Title: Liaison on IETF RFC 7042bis, IANA Considerations and IETF Protocol and Documentation Usage for IEEE 802 Parameters
From: IEEE 802.1 Working Group
For: Information
To: Eric Kline, Internet Area Director, ek.ietf@gmail.com
Éric Vyncke, Internet Area Director, evyncke@cisco.com
Donald E. Eastlake 3rd, d3e3e3@gmail.com
Joe Abley, jabley@hopcount.ca
Yizhou Li liyizhou@huawei.com
IETF Liaisons, statements@ietf.org
Janos Farkas, IETF/IEEE 802.1 liaison, Janos.Farkas@ericsson.com
Russ Housley, IETF/IEEE 802 Coordination Chair, housley@vigilsec.com
Dorothy Stanley, IEEE 802/IETF SC Chair, dorothy.stanley@hpe.com
Copy: Glenn Parsons, Chair, IEEE 802.1, glenn.parsons@ericsson.com
Jessy Rouyer, Vice-Chair, IEEE 802.1, jessy.rouyer@nokia.com
Paul Congdon, Chair, IEEE 802.1 Maintenance Task Group, paul.congdon@tallac.com
Roger Marks, Chair, IEEE RAC, roger@ethair.net
Angela Thomas, Secretary, IEEE RAC, a.n.thomas@ieee.org

The IEEE 802.1 Working Group and the IEEE Registration Authority Committee have reviewed the Internet-Draft IETF RFC 7042bis, *IANA Considerations and IETF Protocol and Documentation Usage for IEEE 802 Parameters* (<https://datatracker.ietf.org/doc/html/draft-ietf-intar

Figure 1. 48-bit MAC Address Structure

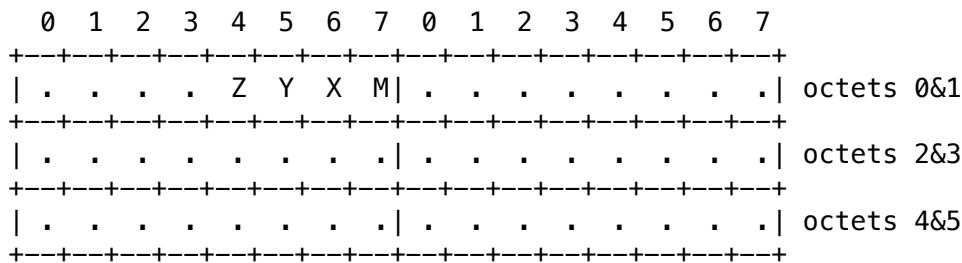
The bottom four bits, as shown in Figure 1, of the first octet of the first octet 48-bit MAC have special meaning and are referred to below as the M, X, Y, and Z bits.

~~Except for certain combinations of the Z, Y, X and M bits as discussed in Section 2.1.1~~ For global addresses, X=0 and, a MAC address begins with 3 octets or a larger

A CID is a 24-bit Company Identifier. It is assigned for organizations that need such an identifier, that can be used in place of an OUI, but do not need to assign ~~subsidiary~~ global MAC addresses. ~~A CID can be recognized by its X and Z bits having the value 1 and its Y bit having the value 0 (see Figure 1).~~ A CID has X and Z bits equal to 1 and its Y bit equal to 0 (see Figure 1).

Figure 2. ~~EtherType~~EtherType Frame Protocol Labeling

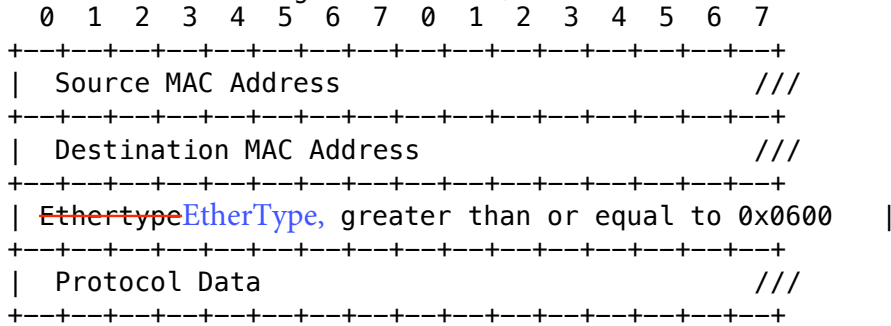
~~EtherTypes~~EtherTypes: These are 16-bit identifiers appearing as the initial two octets after the MAC destination and source (or after a tag), which, when considered as an unsigned integer, are equal to or larger than 0x0600. (See Figure 2.) [802_0&A] specifies two ~~EtherTypes~~EtherTypes for local, experimental use: 0x88B5 and 0x88B6.
